Upper South Creek Advanced Water Recycling Centre – Response to Request for Information

1 July 2022

Figure 1 – Impacts to ENV

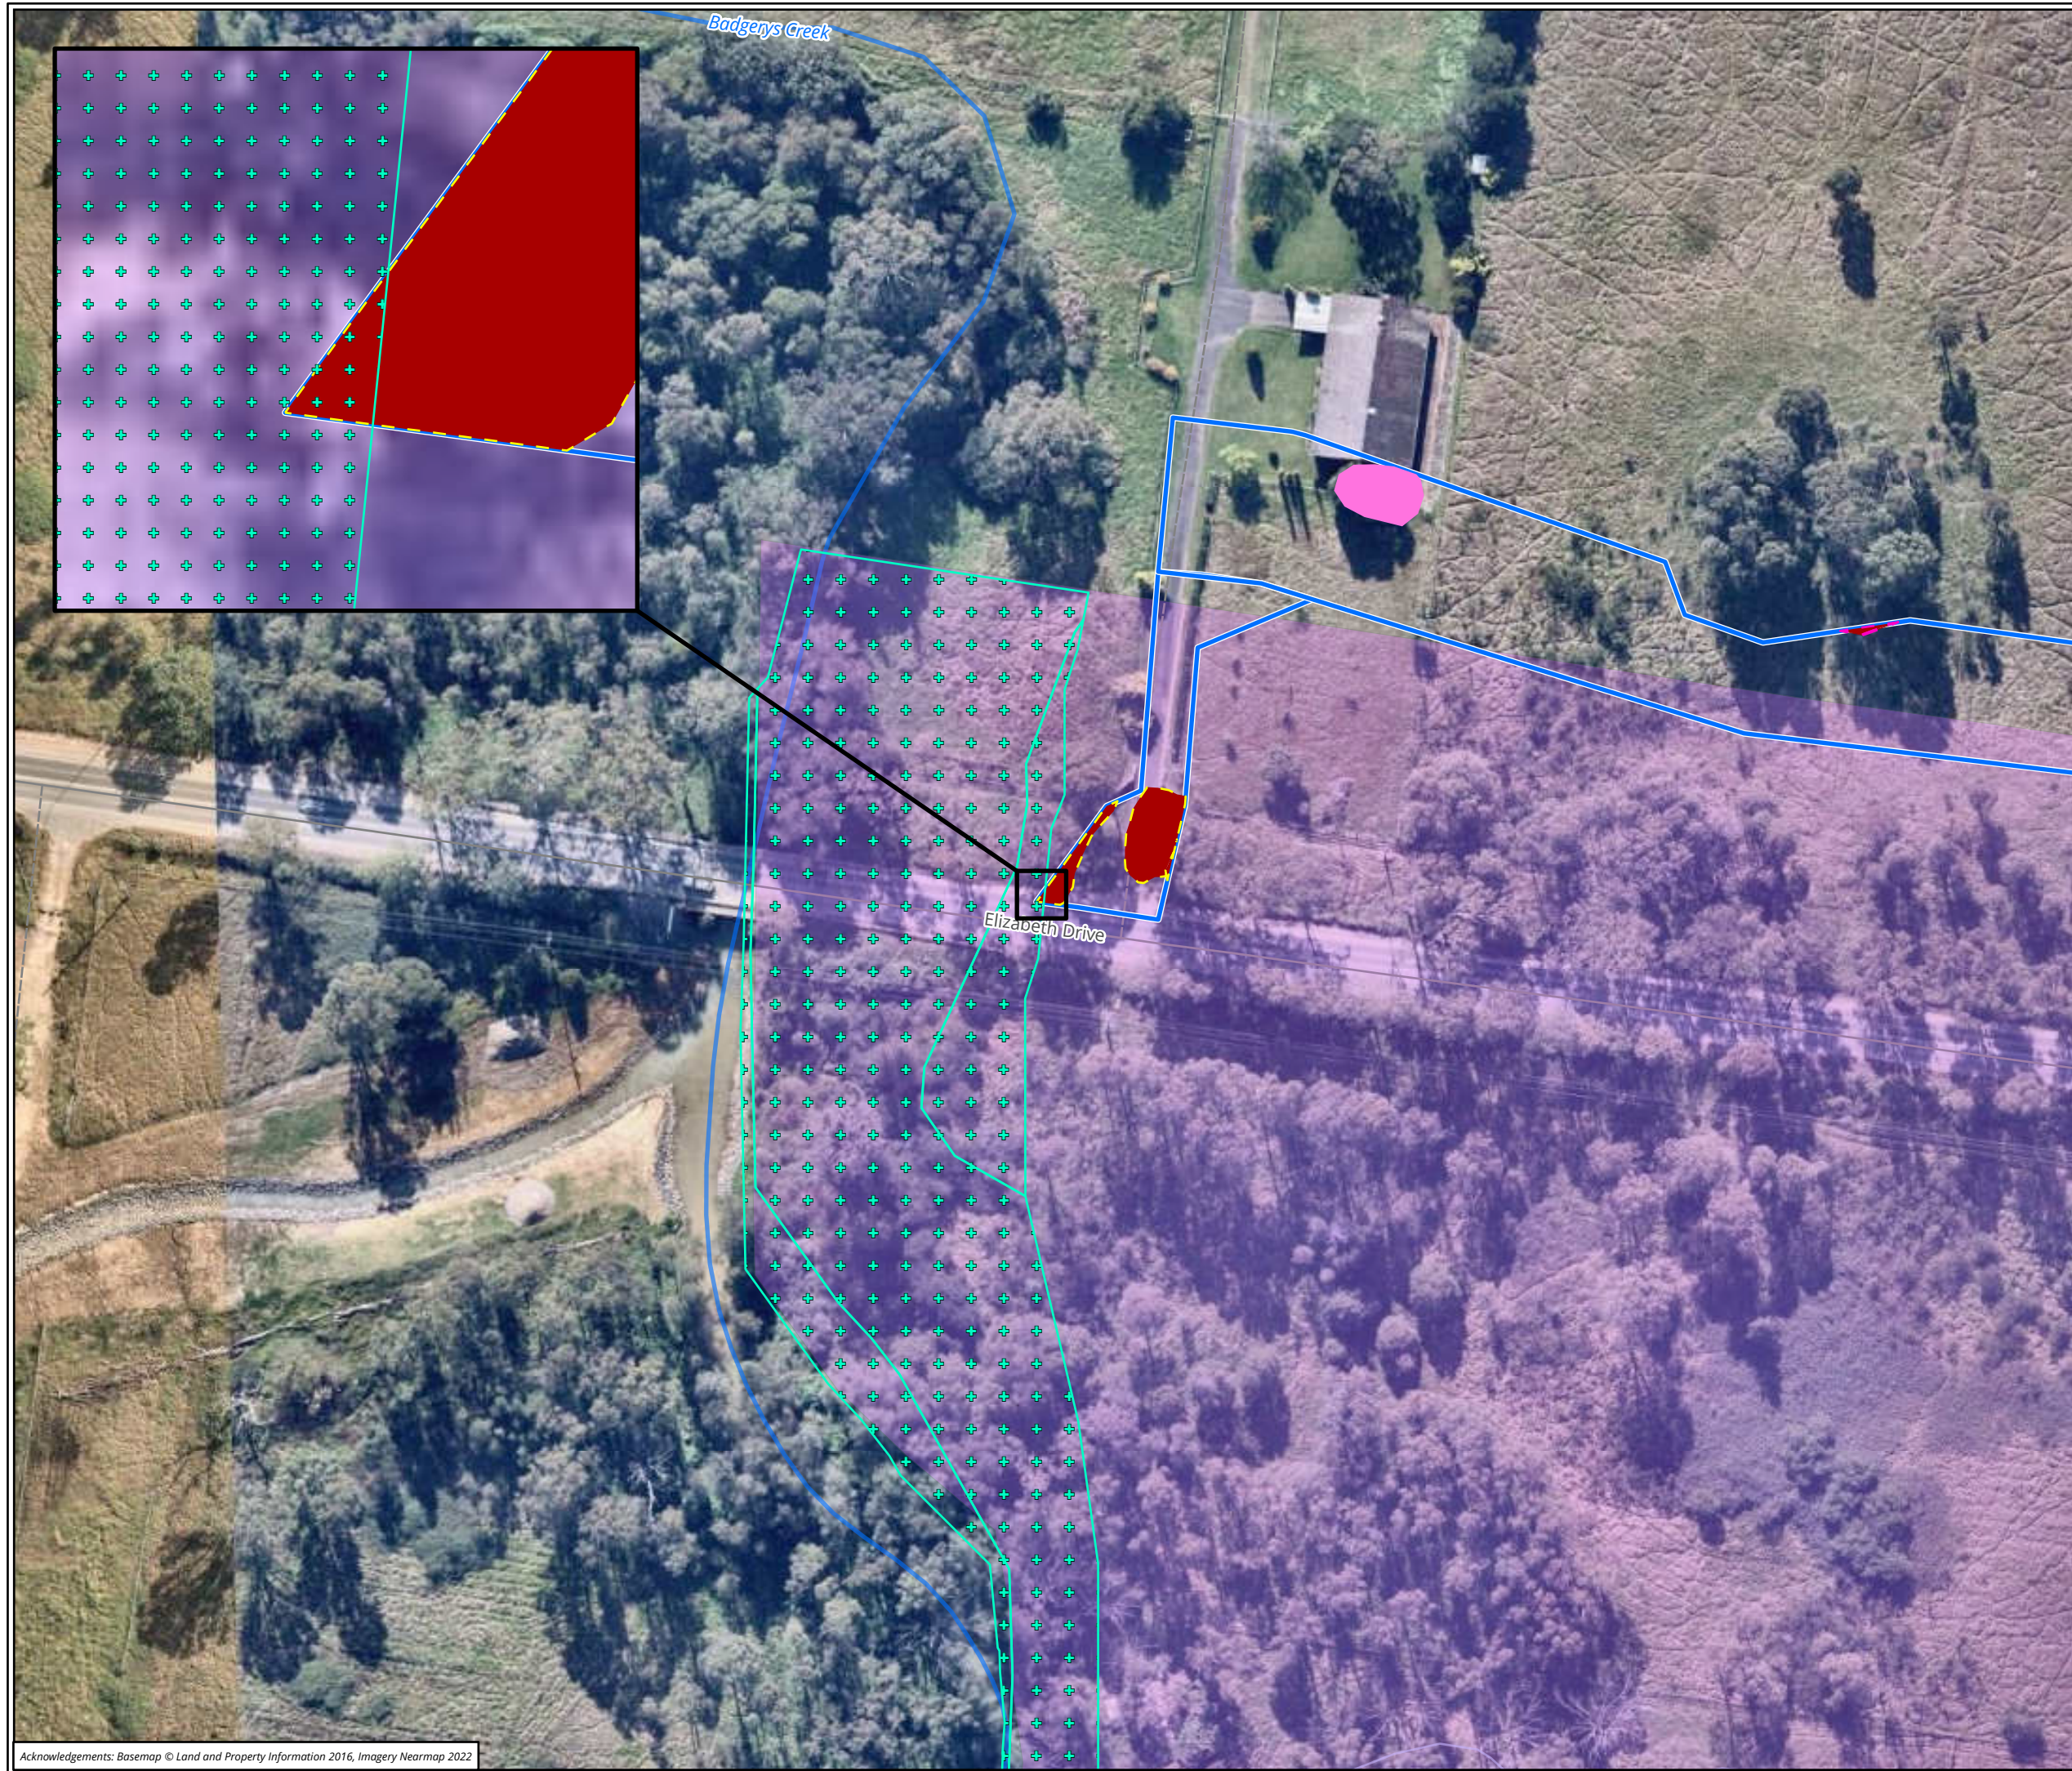
Issue	Response
<p>Sydney Region Growth Centres Biodiversity Certification – conditions of approval</p> <p>Requests several recommended conditions in relation to impacts on existing native vegetation (ENV) in red hatched land and rehabilitation around Kemps Creek.</p>	<p>Sydney Water considers these are matters for DPE's Water Assessments team and has no further information to add.</p>
<p>Sydney Region Growth Centres Biodiversity Certification - mapping</p> <p>Seeks additional information in the form of maps that depict the location of impacts to ENV (certified and non-certified) from the development in the Growth Centres covered by the Biodiversity Certification Order. The maps should also include the red and black hatched areas. This mapping is required to ensure that impacts within the Growth Centres can be adequately assessed as well as reconciled as part of the annual reporting required under the Order.</p>	<p>Attachment A (Figure 1) includes the requested maps. These maps show all project infrastructure in the area covered by the Biodiversity Certification Order, including where there is no impact on ENV.</p> <p>These maps include insets that show where the project's impact area overlaps with ENV mapped in the Biodiversity Certification Order. The only locations where the project impacts on verified ENV (based on Biosis' ground-truthing) are:</p> <ul style="list-style-type: none"> page 1 – 1.3 m² of PCT 849 in a certified area. page 10 – 6 m² of PCT 849 in a non-certified area. This vegetation is located adjacent to an existing access track which is proposed for use during construction. This track has vegetation on its eastern edge and the WaterNSW Upper Canal to the west. Sydney Water needs to ensure construction vehicles can use this access track which may require this minor clearing or trimming of ENV. Sydney Water will consider during detailed design and construction planning whether impact to this ENV can be avoided.

<p>Sydney Region Growth Centres Biodiversity Certification - offsets</p> <p>EHG seeks a Growth Centres Offset Strategy detailing how it is proposed to meet requirements specified in RBM 8.</p>	<p>As noted above, Sydney Water will consider if these impacts can be avoided during detailed design. If impacts cannot be avoided, Sydney Water would include any offsets required by RBM 8 in the project's overall Biodiversity Offset Strategy (management measure TB10 in Appendix B of the Submissions Report).</p>

The total area of direct impact from the amended project alignment to native vegetation on 'Existing Non-certified' land is 1.43 hectares, of which a total of 6 square metres is considered verified ENV. This is illustrated on the attached figure.

Figure 1. Measured NO_2 to NO_x ratios from hourly data collected at Prospect in 2019

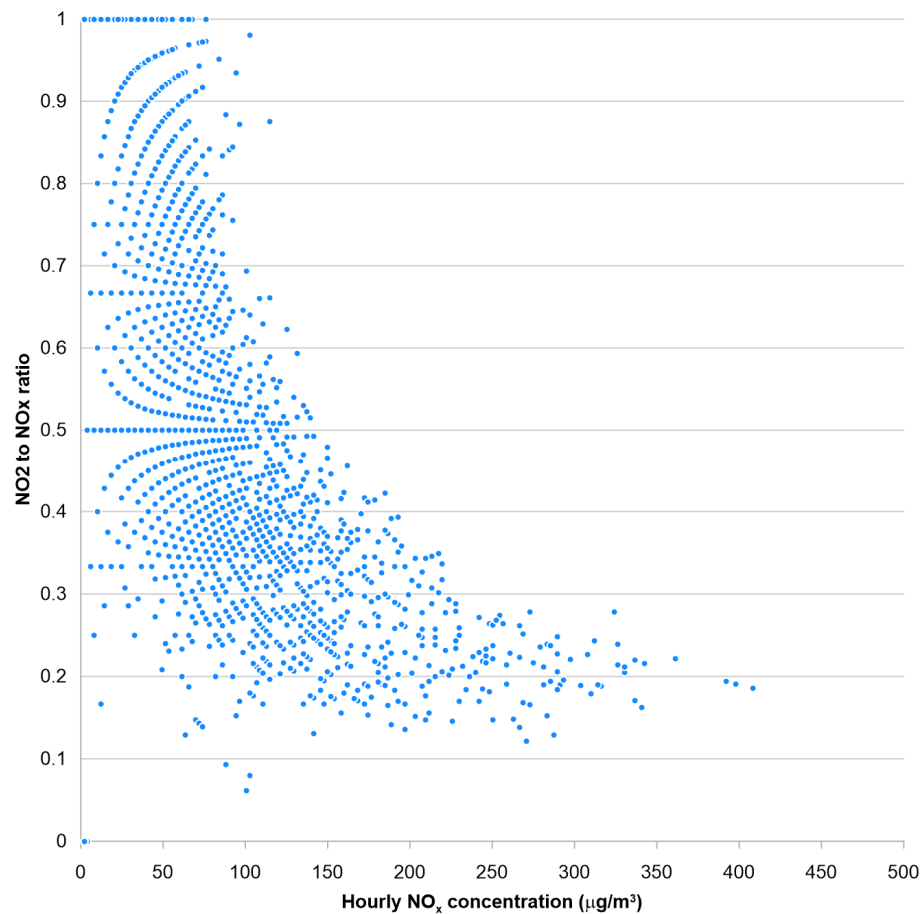
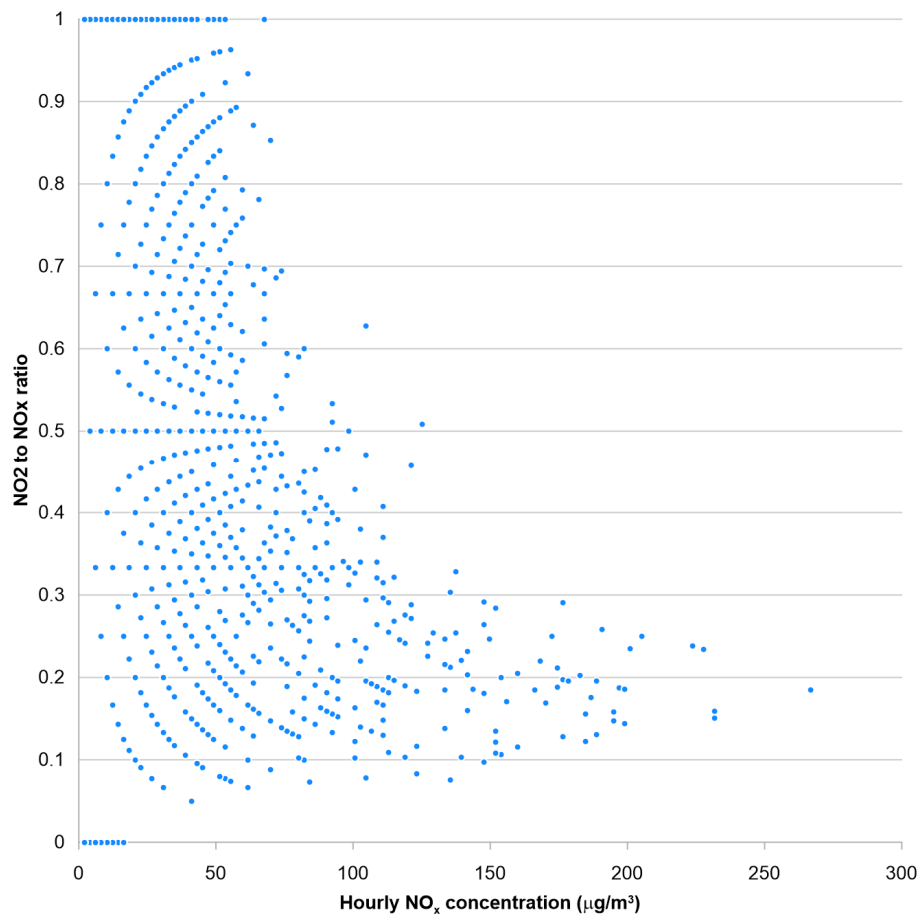
Should the adopted emission performance of 450 mg/m³, or marginally below 450 mg/m³, continue to be proposed, the EPA will require a more robust assessment of nitrogen oxides be performed in accordance with the Approved Methods for the Modelling and Assessment of Air Pollutants. The assessment must:

The NO_x monitoring data in Sydney show that the percentage of NO₂ in the NO_x is inversely proportional to the total NO_x concentration, and when NO_x concentrations are high, the percentage of NO₂ in the NO_x is typically of the order of 20%. This is demonstrated by Figure 1

and Figure 2 which show that, for high NO_x concentrations at the nearby Prospect and St Marys monitoring stations, the NO_2 to NO_x ratio reduces to less than 20%.

Figure 3. Predicted maximum 1-hour average NO₂ concentrations due to co-generation

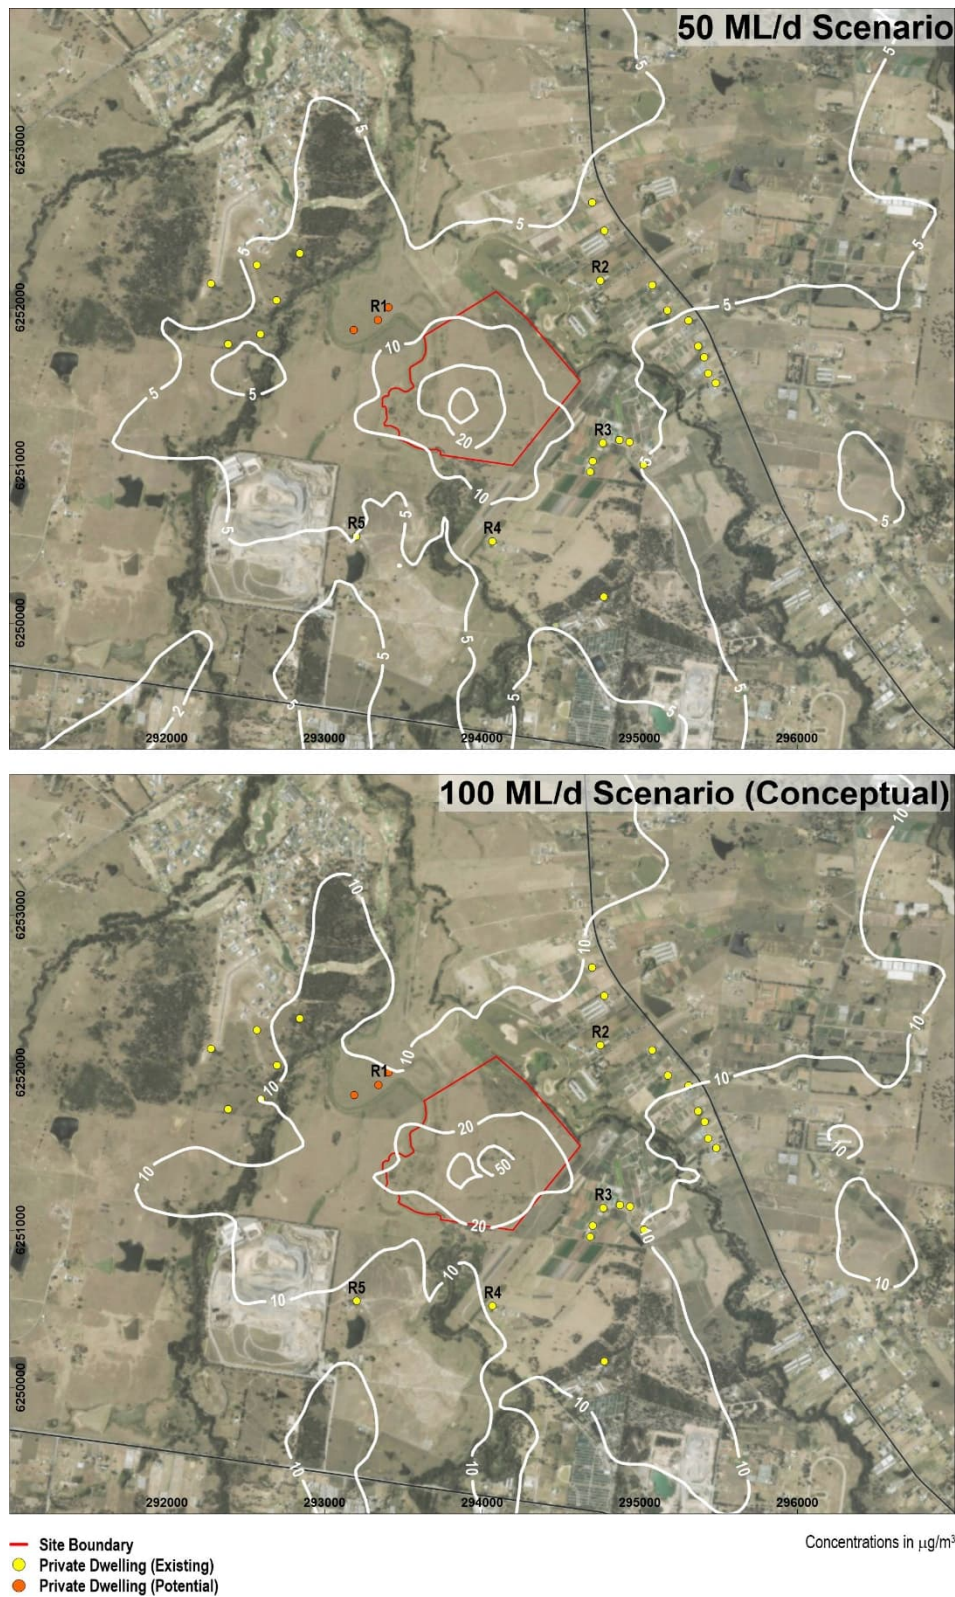
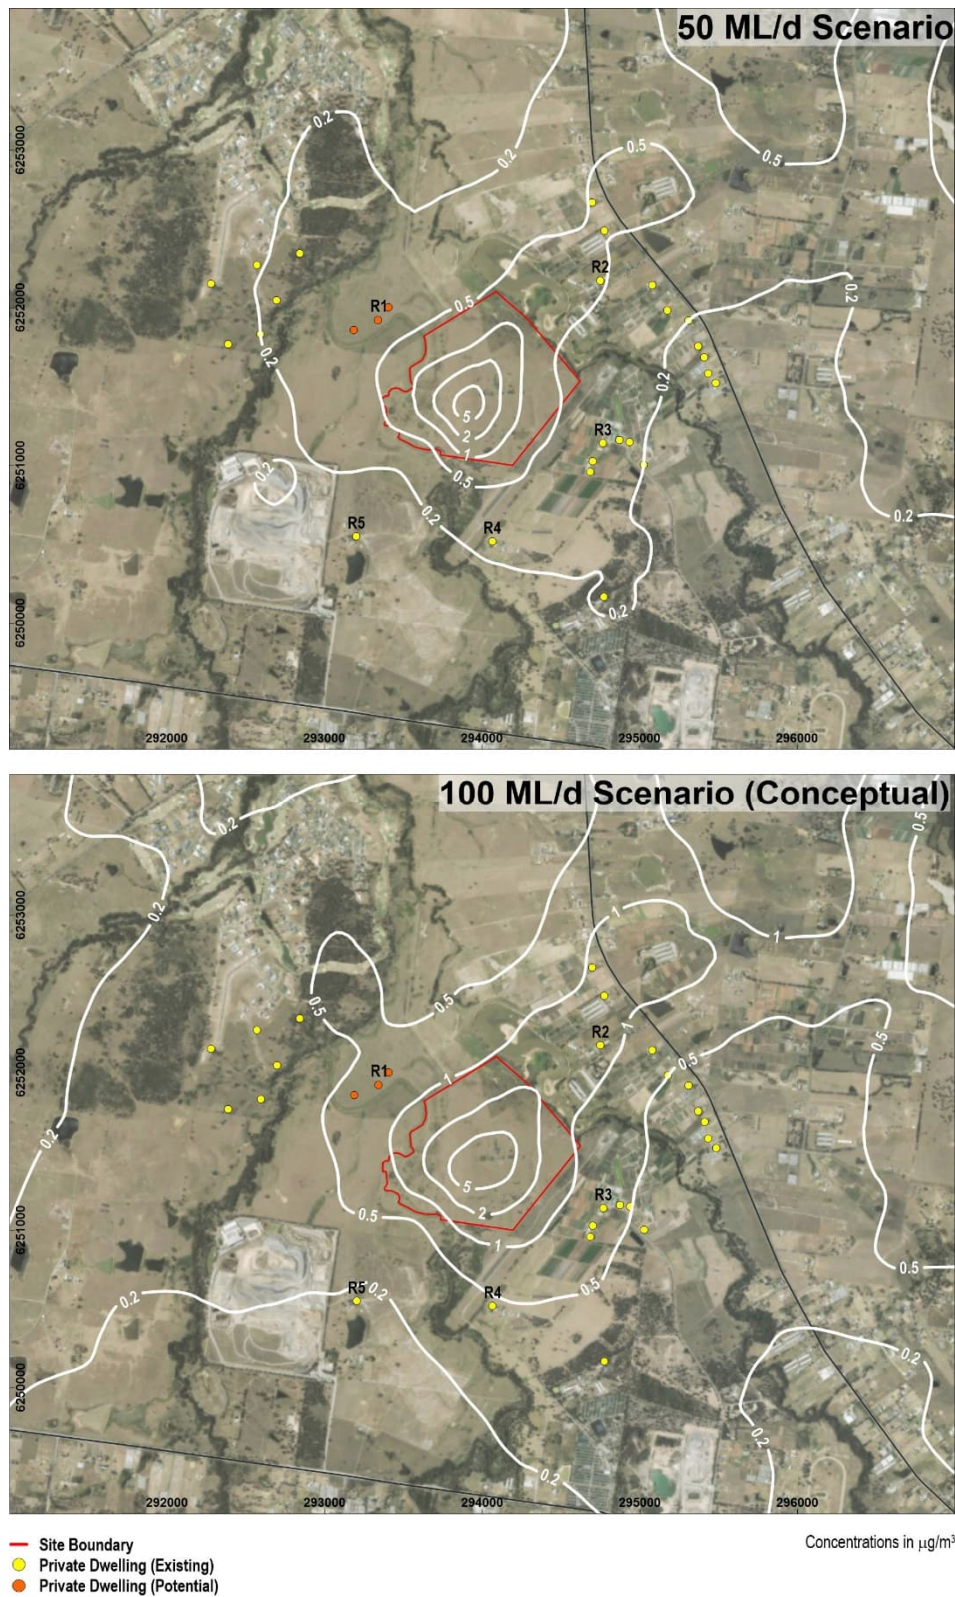
- *Include a worst-case operating scenario for NO₂ impacts*
- *Present all predicted incremental and cumulative impacts of NO₂ for each modelled scenario at all existing and future receptors*
- *Consider the 2021 one hour and annual average NO₂ AAQ NEPM standards.*

Figure 3 shows the predicted maximum 1-hour average NO_2 concentrations, at ground-level, due to the Project under the 50 and 100 ML/d scenarios. These results assume that 30% of the NO_x is NO_2 at the locations of maximum (1-hour average) ground-level concentrations. As noted above, the DPE monitoring data show that NO_2 will only be in the order of 20% of the NO_x for maximum levels so 30% is a conservative assumption.

At the nearest sensitive receptors, the predicted maximum 1-hour average NO_2 concentrations are less than $20 \mu\text{g}/\text{m}^3$ under the worst-case 100 ML/d scenario. With the addition of maximum background levels for the selected model year ($103 \mu\text{g}/\text{m}^3$) the cumulative results (i.e. $123 \mu\text{g}/\text{m}^3$ or less) demonstrate compliance with the EPA's assessment criterion ($246 \mu\text{g}/\text{m}^3$) criterion. The results also demonstrate compliance with the 2021 NEPM Standard ($162 \mu\text{g}/\text{m}^3$).

Figure 4 shows the predicted annual average NO_2 concentrations due to the Project under the 50 and 100 ML/d scenarios. These results assume that 100% of the NO_x is NO_2 since more conversion can occur over longer averaging times. At the nearest sensitive receptors, the predicted annual average NO_2 concentrations are less than $2 \mu\text{g}/\text{m}^3$ under the worst-case 100 ML/d scenario. With the addition of maximum background levels for the selected model year ($25 \mu\text{g}/\text{m}^3$) the results demonstrate compliance with the EPA's assessment criterion ($62 \mu\text{g}/\text{m}^3$) criterion. The results also demonstrate compliance with the 2021 NEPM Standard ($30 \mu\text{g}/\text{m}^3$).

Table 2 provides tabulated results for the nearest existing and potential sensitive receptors, where the receptor locations are shown on Figure 3 and Figure 4. The data from Table 2 show that NO₂ concentrations at the nearest sensitive receptors will not exceed the EPA assessment criteria or more stringent 2021 NEPM Standards.
